20-WL-0187
page 2

Site Name: Merritt Properties LLC
Facility Address: 435 Ginn Lane, Pasadena, MD 21122
County: Anne Arundel County

RE: MDE response to comments.

RE: Agency Interest Number: 85638
Tracking: 202060236
Tidal Authorization/Applications Numbers: 20-WL-0141EX/20-WL-0187
Address: 435 Ginn Ln, Pasadena MD 21112

Tidal Wetlands Revetment Placement Review - Permit Map

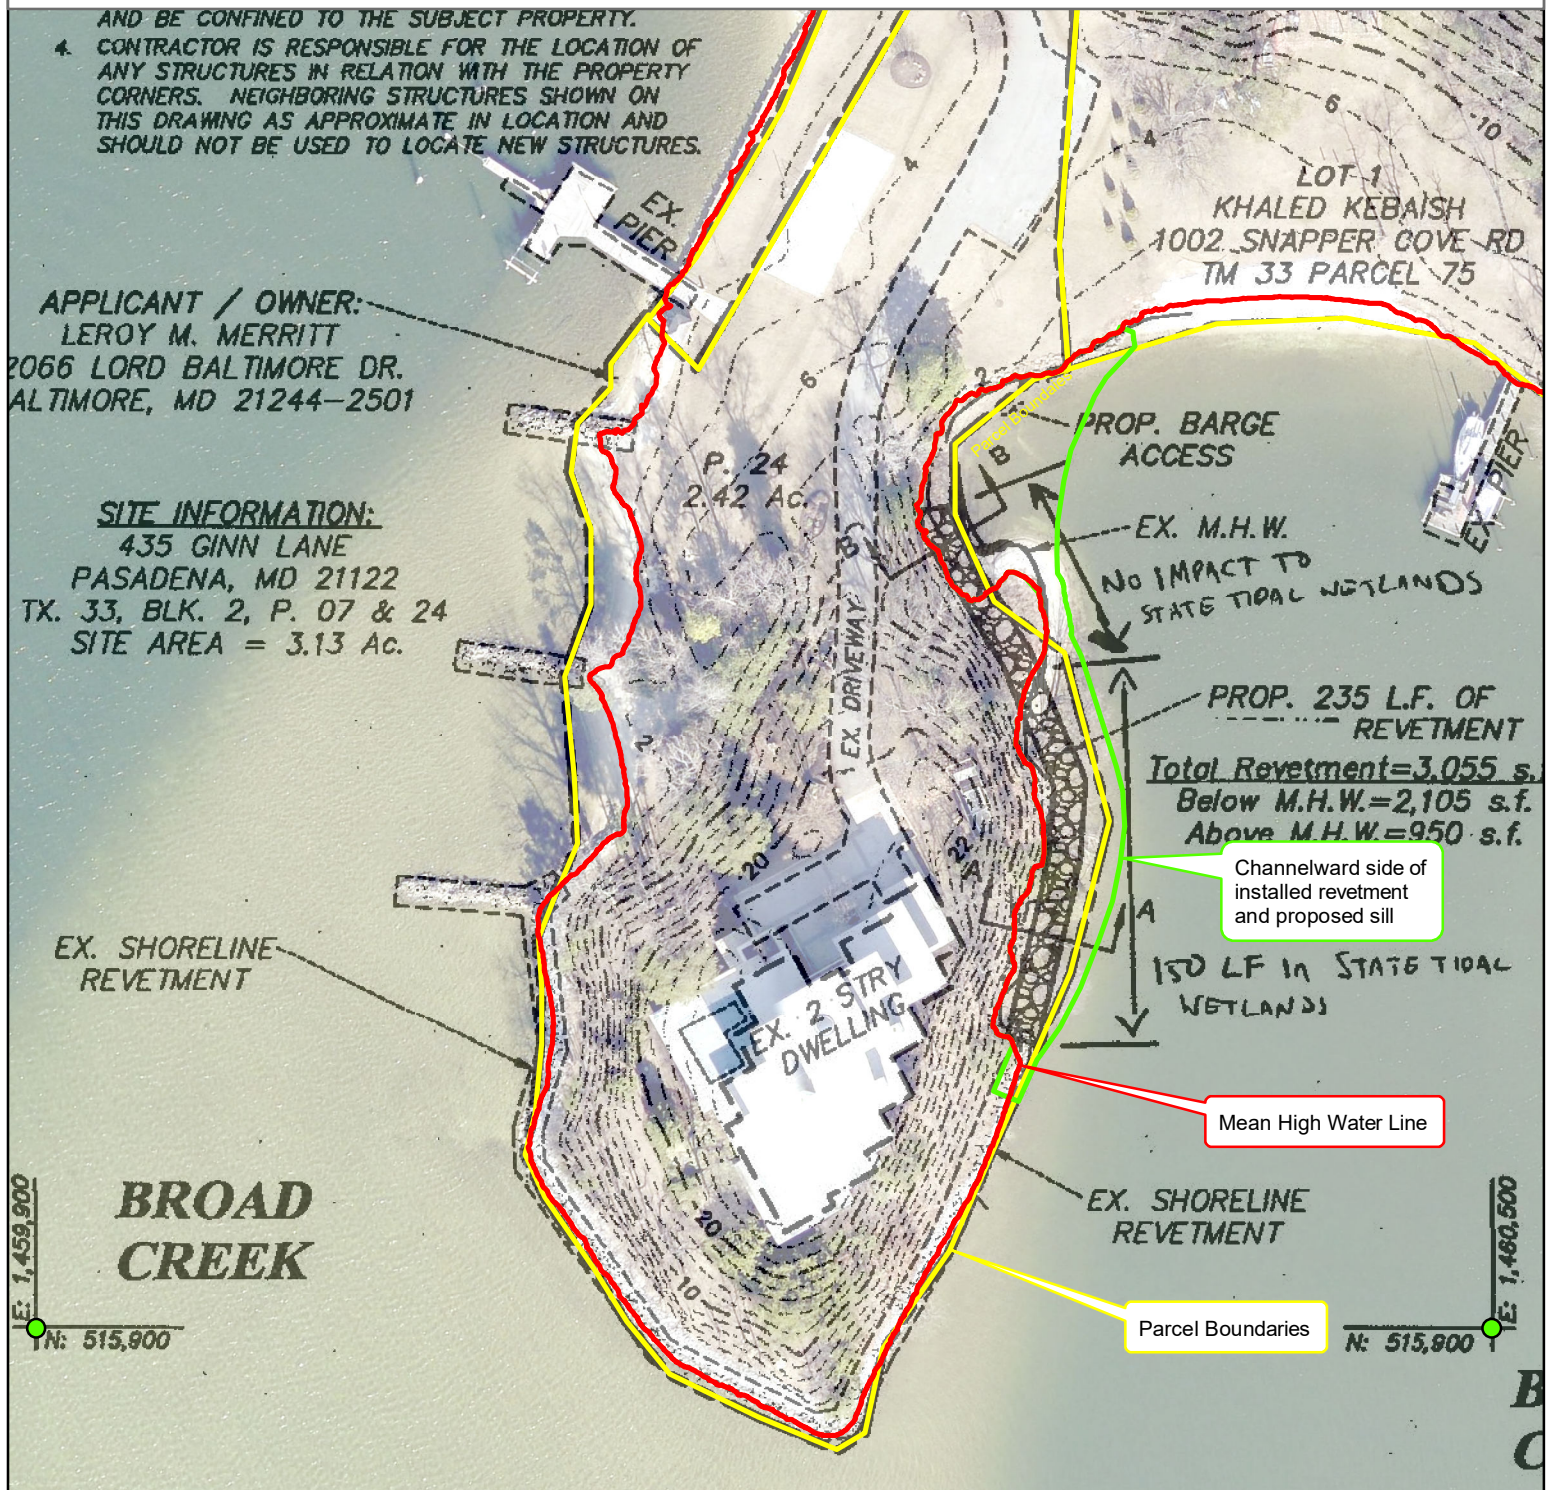
The Maryland Department of the Environment ("Department" or "MDE") has reviewed comments and documents received from a citizen. Specifically, the citizen was concerned the channelward encroachment extended 40-50' channelward of the mean high water line (MHWL) and not 21' as depicted on the site plan. The Department reviewed the provided information in addition to other information. In coordination with MDE's GIS specialist, the Department determined the following:

- 1) The maximum encroachment of revetment extends 38 feet channelward of the mean high water line.
- 2) An area measuring approximately 150 linear feet by 23 feet wide (fill beyond 10-feet from the MHWL) requires mitigation associated with permanent shallow water impacts. This area (for all fill beyond 10-feet channelward of the mean high water line with a maximum encroachment of 38 feet) is 3,435 square feet (see map: Ginn Ln Results. As discussed previously, an out-of-kind mitigation project requires mitigation at 2:1, thus the Department requires a project resulting in marsh creation to equal 6,870 square feet of planted marsh.
- 3) The proposed mitigation is depicted extending over the extended property line.

- 1) Existing Revetment.
 - a. Due to the provided justification to stabilize the slope and the historic property line (depicted on the attached maps), the Department determined that the plan set for the installed revetment is complete and may proceed with a review, provided mitigation is agreed upon for the loss of shallow water habitat and is included in an application;

- b. As was previously discussed, the Department can authorize the 150 linear feet of revetment that was intended in 20-0141 and an additional 30 linear feet for a total of 180 linear feet north of the previously emplaced revetment.

- c. North of the 180 linear foot mark: based on a combination of the information we have before us and the criteria we must presently use to determine whether a site is eligible for a waiver from the living shoreline requirement, this section does not appear to be eligible for a waiver from the living shoreline requirement, thus the revetment should be removed.

- 2) Mitigation.
- a. Please revise the proposed marsh creation/mitigation so it will not cross the extended property line as depicted on the attached maps.

- b. To help address concerns regarding channelward encroachment, the Department recommends keeping the proposed marsh and stone sill to a maximum of 35 feet channelward of the original mean high water line, which was the proposed encroachment in your resubmittal.
